R22CB

SECOND FINAL NOTICE

DATE: January 11, 2024
TO: Blue Bird Owners
Subject: R22CB: 7.3L Gas Supply Line And Shifter Cable Interference

7.3L SHIFT CABLE-GASOLINE FUEL LINE INTERFERENCE

Fig 1

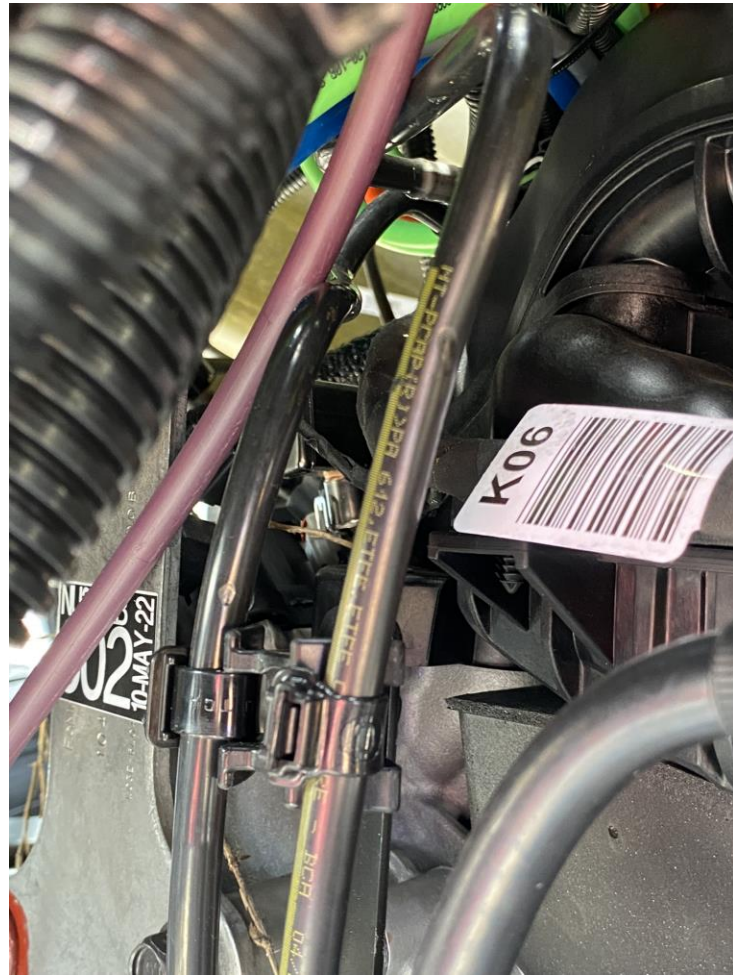
Step 1: Inspect the left rear corner of the engine from the top, and the bottom. If there is greater than 3” of clearance between the shift cable and the fuel line, no further action is required. Ref. Figure 1 for an example of insufficient clearance. If <3” of clearance, proceed to step 2.

Fig 2

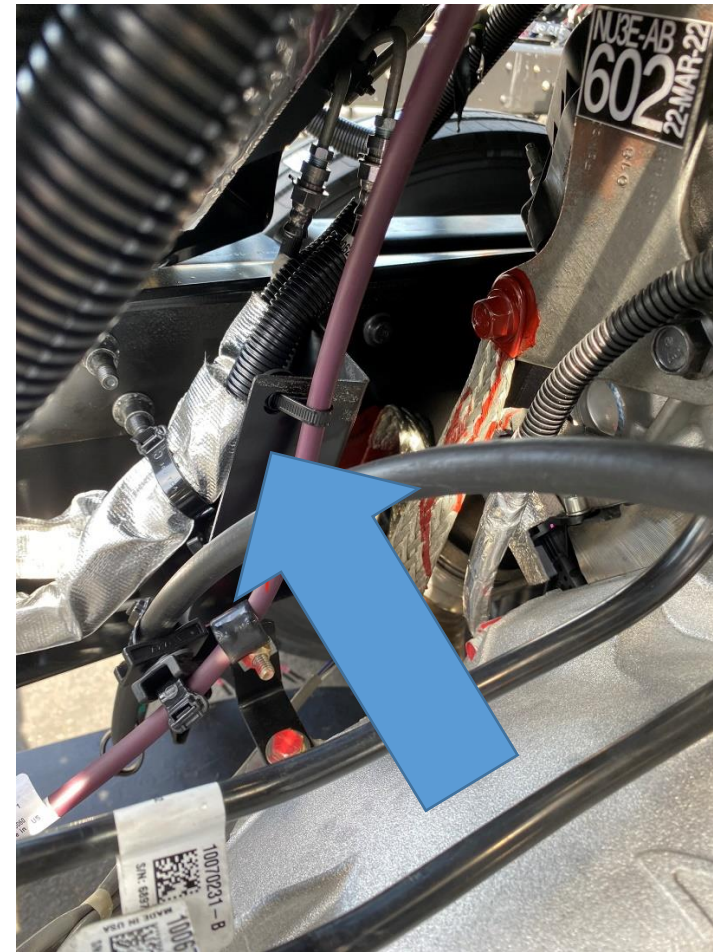
Step 3: Verify the heat shield bracket (Item 2), regardless of brake type is in place. Reference Figure 2. If missing, install per Figure 3.

Fig 3

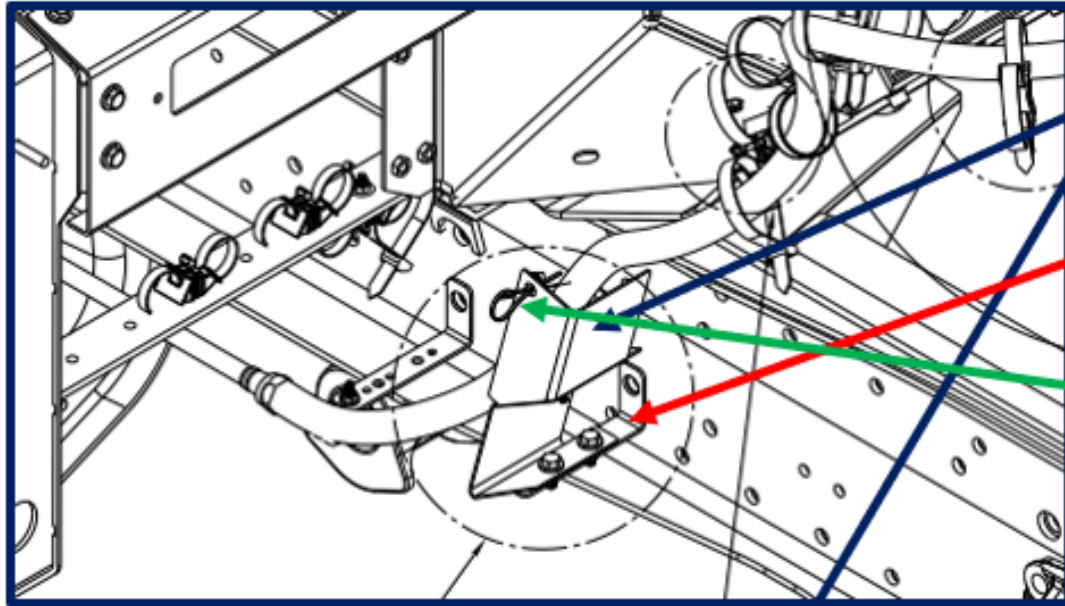
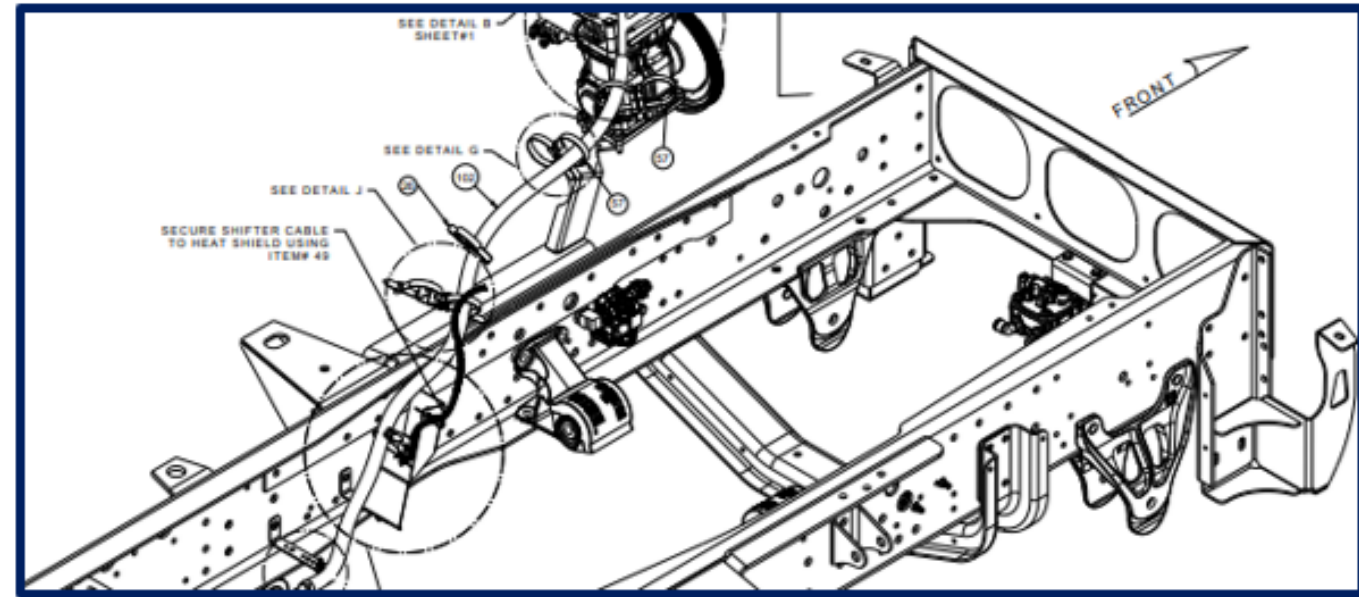
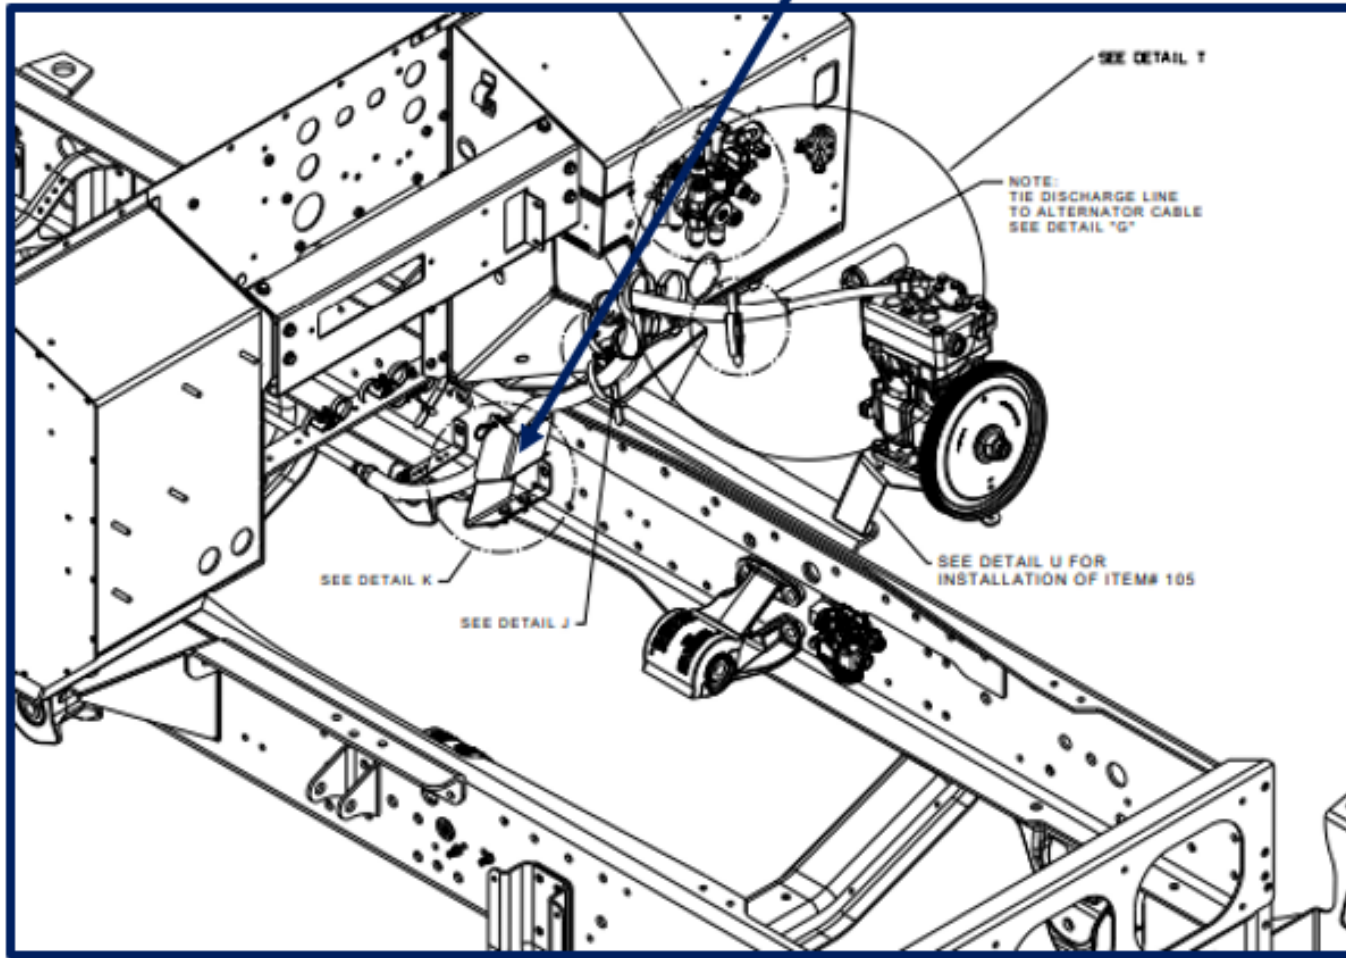
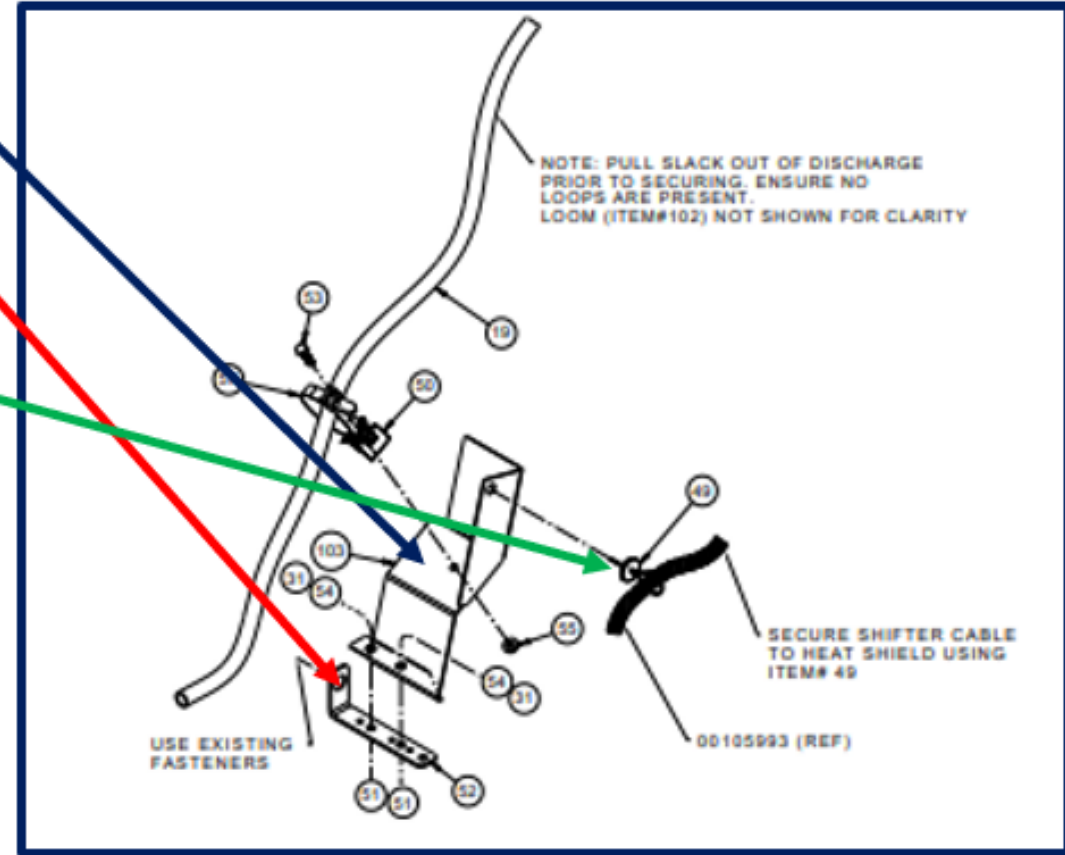
Step 4: Verify shift cable is routed properly and secured to the bracket with the HD button cable tie, p/n 00024076 per Figure 3

Fig 4

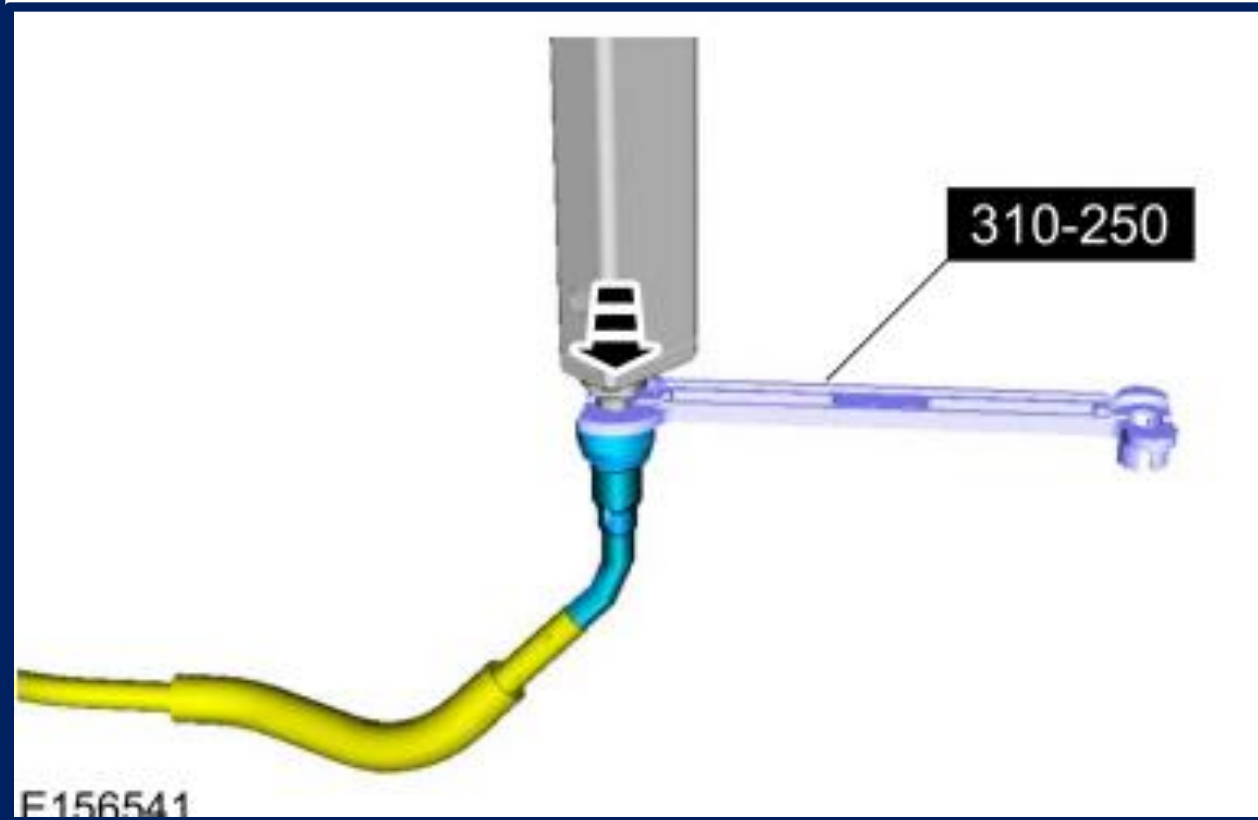
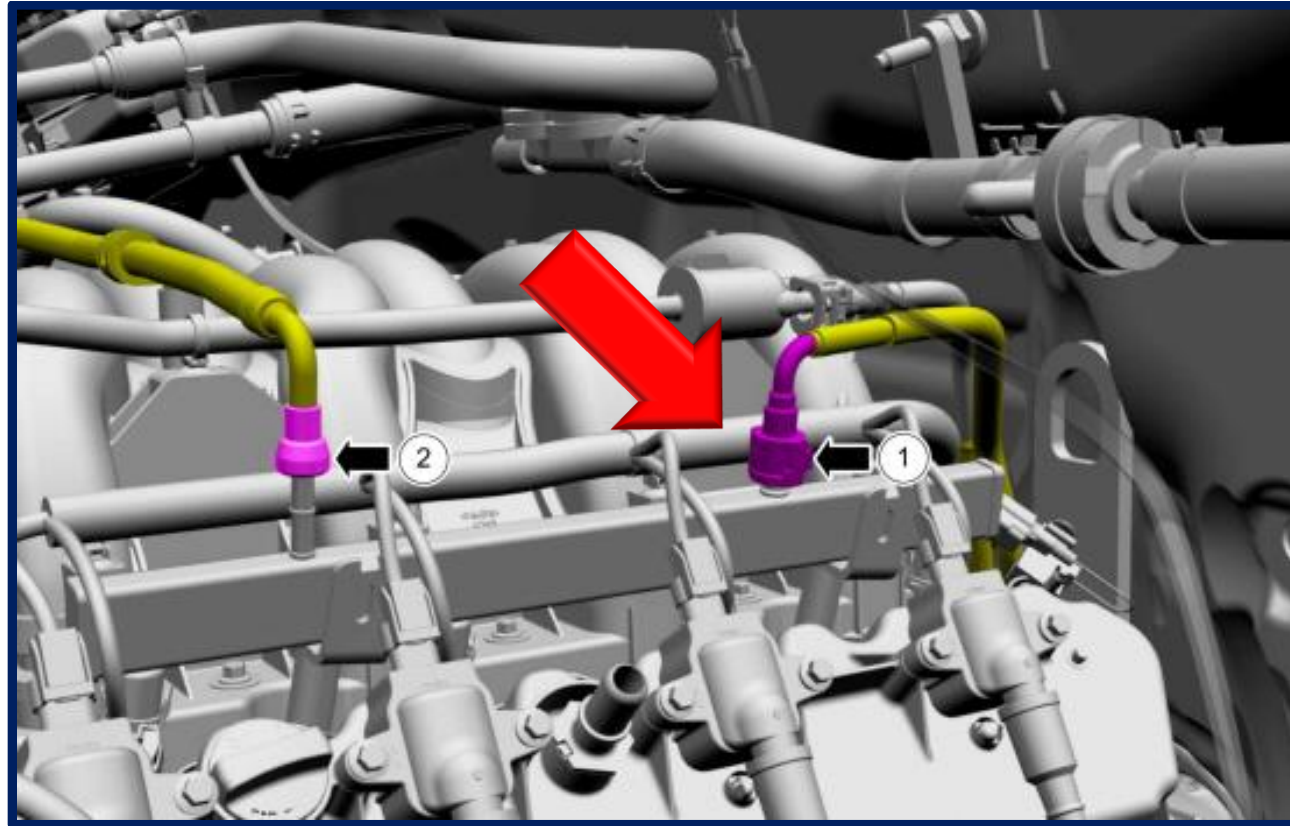
D- Wearing appropriate PPE, lay an absorbent cloth below the fuel line connection at the fuel rail and slowly disconnect the fuel line using Rotunda 310-250 or equivalent. See Figure 4
